Access Compliance Report

Public Rights-of-Way

(Curb Ramps)

Intersection ID: 11847	Main Street: E_9TH_ST	Cross Street: N_TRYON_ST	Location: E
ADA ID: FD163419FB0B	Ramp Type: PerpDiag	Initial Pass/Fail: Fail	Overall Compliance: No
Severity Score: 13.75			
Codes/Mitigation Info/Possible Solution		Field Measurements/Component Compliance

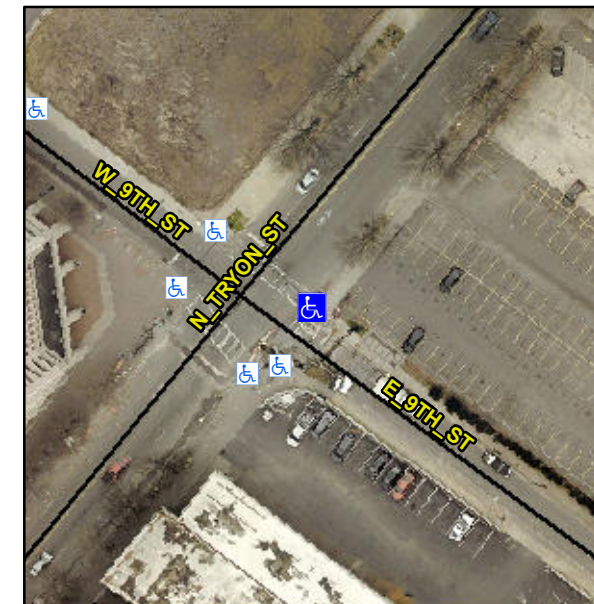
Not Found, R304.2.2, R304.5.3

Compliance	Description	Data	Compliance	Description	Data
N/A	Ramp Length (in)	49.0	No	Ramp Slope (%)	11.0
Yes	Ramp Width (in)	48.0	No	Ramp XSlope (%)	2.1
N/A	Flare Type LT	N/A	N/A	Flare Type RT	N/A
N/A	Flare Slope LT (%)	N/A	N/A	Flare Slope RT (%)	N/A
N/A	Flare Traversable LT?	N/A	N/A	Flare Traversable RT?	N/A
N/A	Landing Length (in)	N/A	N/A	DWS Provided?	N/A
N/A	Landing Width (in)	N/A	N/A	DWS Contrast?	N/A
N/A	Landing Slope (%)	N/A	N/A	DWS Length (in)	N/A
N/A	Landing X Slope (%)	N/A	N/A	DWS Full Width?	N/A
N/A	Landing Curb? (Y/N)	N/A	N/A	DWS Offset (in)	N/A
N/A	Shared Landing?	N/A			
N/A	Gutter Ponding?	N/A	N/A	Gutter Slope (%)	N/A
N/A	Gutter Lip Ht (in)	N/A	N/A	Gutter X Slope (%)	N/A
N/A	Painted X Walk1?	Yes	N/A	Painted X Walk2?	Yes
	X Walk 1 Direction	To NW		X Walk 2 Direction	To SW
N/A	X Walk 1 Width (in)	104.0	N/A	X Walk 2 Width (in)	110.0
	X Walk 1 Slope (%)	6.1		X Walk 2 Slope (%)	5.1
	X Walk 1 X Slope (%)	1.4		X Walk 2 X Slope (%)	3.4

Remove & Replace Curb Ramp With Two New Directional Ramps or Equivalent.
